## CITY of NOVI CITY COUNCIL

**Agenda Item 1**  
**March 26, 2012**

**SUBJECT:** Consideration of the request of Beck Ten Land, LLC for ZCM12-02 with Zoning Map Amendment 18.701 to rezone property in Section 20, on the northwest corner of Beck Road and Ten Mile Road from R-1, One-Family Residential to R-3, One-Family Residential with a Planned Rezoning Overlay. The property totals 24.24 acres and the applicant is proposing a 38 unit single-family residential development.

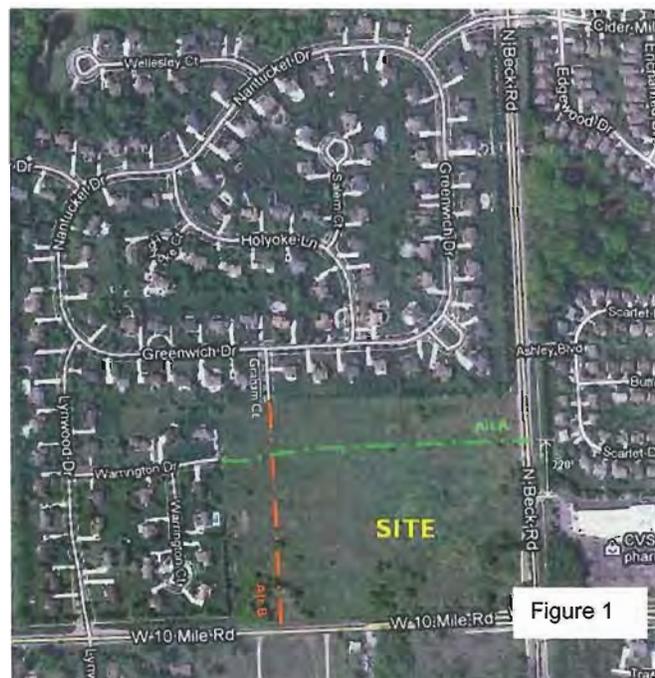
In addition to the existing plan without direct connections to 10 Mile or Beck, we have evaluated the two potentially feasible alternatives illustrated in Figure 1. Alternative A would extend Warrington directly east, along the south side of the northeast "Open Space," to an intersection with Beck that would be about 220 ft north of the driveway for Briar Pointe Plaza (center-to-center). Alternative B would extend Graham Lane directly south, through the middle of the southwest "Open Space," to an intersection with 10 Mile Road.

Delays and risks for *exiting left turns* would be roughly comparable between the three access plans. Such turns at unsignalized locations would be slightly greater in number for the Proposed Site Plan and Alternative B – 8, all onto 10 Mile – than for Alternative A – 5, all onto Beck. However, exposure to possible crashes would be more similar, since 10 Mile carries less traffic (about 16,000 vehicles per day) than does Beck (about 20,000 vehicles per day).

Greater differences would exist relative to the number of *entering left turns*. Alternative A would generate significantly more such turns – 20 versus 6 for the other two access plans – a factor to consider since

**Needed Improvements to Existing Roads** – Assuming that Beck now serves 20,000 vehicles per day adjacent to the site, a center left-turn or passing lane would be warranted if the peak-hour entering left-turn volume is 10 or more vehicles (per Figure IX.8 in the City's Design and Construction Standards). Hence, the forecasted 14 entering left turns into Alternative A's Warrington extension would warrant left-turn lane improvements.

Per Figure 2, Beck's existing center lane near the shopping center driveway would have to be extended approximately 100 ft further north (about 65 ft to reach the Warrington centerline, plus another 35 ft to satisfy DCS Figure IX.7). The taper north of the full-width center lane would occur all on the east side of the road; by accepted national standards, that taper should at least 270 ft long, as it now appears to be (for a 12-ft-wide offset tapered at a rate equal to half the speed limit, or 22.5:1).

Assuming that 10 Mile now serves about 16,000 vehicles per day adjacent to the site, a center left-turn or passing lane would be warranted if the peak-hour entering left-turn volume is 14 vehicles or more (per DCS Figure IX.8). Since Alternative B's Graham extension is forecasted to serve only 6 entering left turns, a passing lane would *not* be warranted (absent the diversion of 8 or more vehicles now turning left into Lynwood).

Figure 1. Wetland in the area designated as proposed "Retention" on the Plan. North of 10-Mile road, looking north (ECT, February 12, 2010).

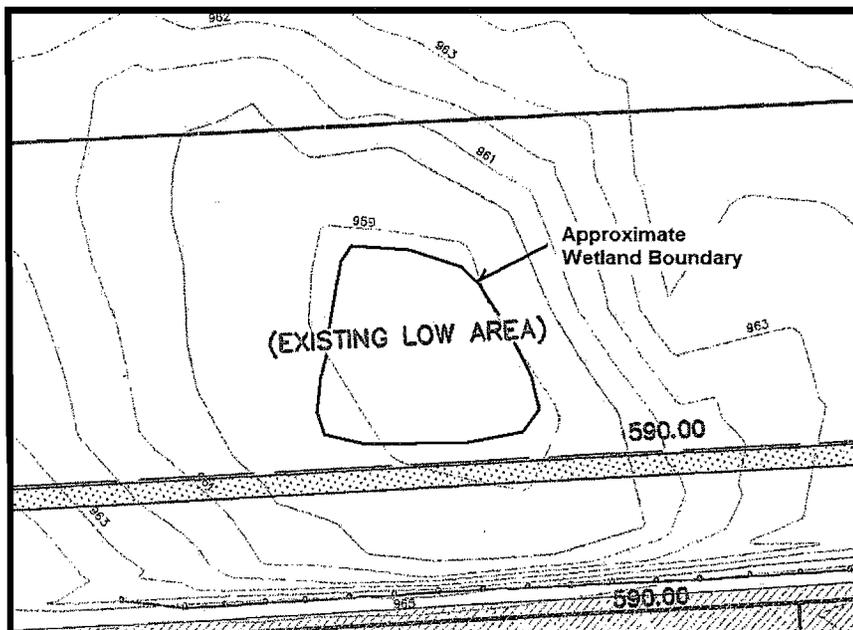
The proposed project site is mostly idle field with scattered shrubs and a few trees. One small wetland (Figure 1) was found near 10-Mile Road in an area labeled on the Plan as "Retention Area." This small wetland is approximately 80-feet in diameter, or less than 5,000 square feet (0.12-acre) (Figure 2). Dominant vegetation includes reed canary grass (*Phalarus arundinacae*), common reed (*Phalarus arundinacae*), and a small clump of black willow (*Salix nigra*). Hydric soils consisted of mucky loam, containing high organic matter content, and oxidized roots met a primary wetland hydrology criterion.
